| Project Title: | Lafayette Backup Generating Facility |
| Document Title: | LBGF Updated FAA No Hazard Determinations |

Aeronautical Study No.
2020-AWP-12505-OE

**** DETERMINATION OF NO HAZARD TO AIR NAVIGATION ****

Additional information for ASN 2020-AWP-12510-OE

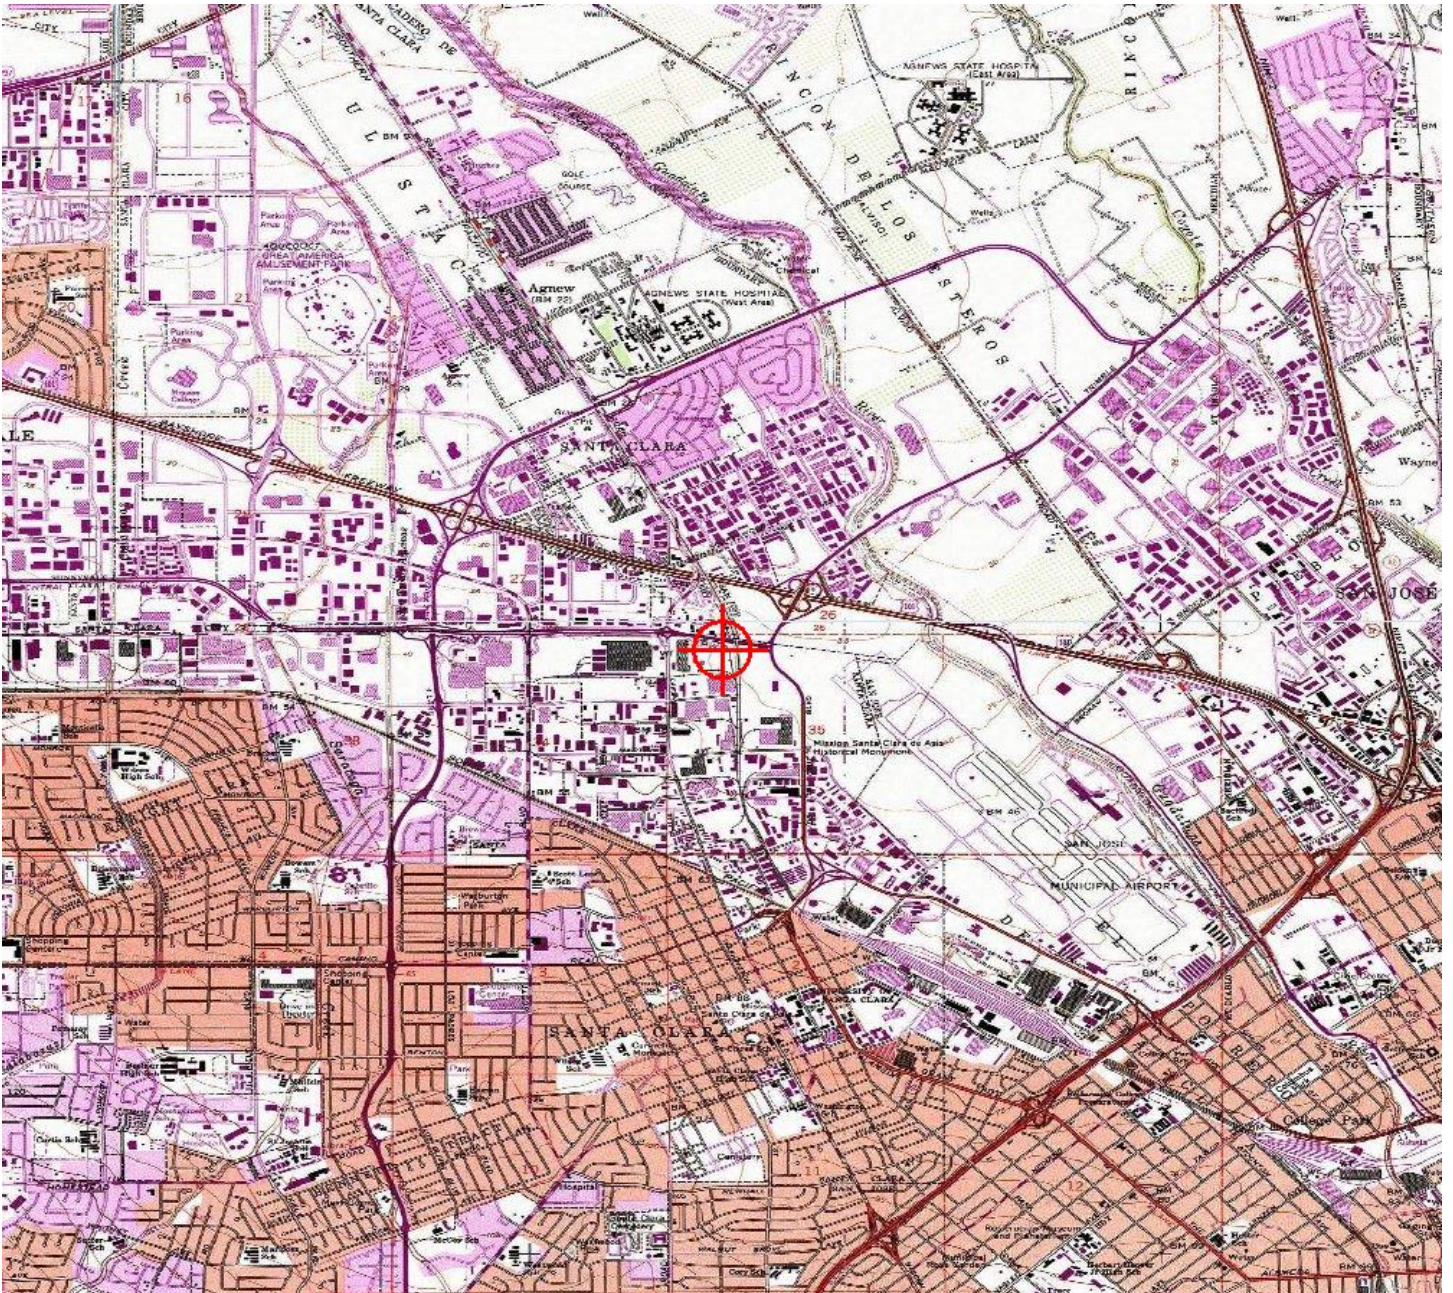
This building will be located in very close proximity to the threshold of the Norman Y. Mineta San Jose International Airport (SJC) Runway (RWY) 12R. Occupants and people outside the building will be exposed to frequent loud jet aircraft noise and the sight of large commercial aircraft operating at very low altitudes near the building.
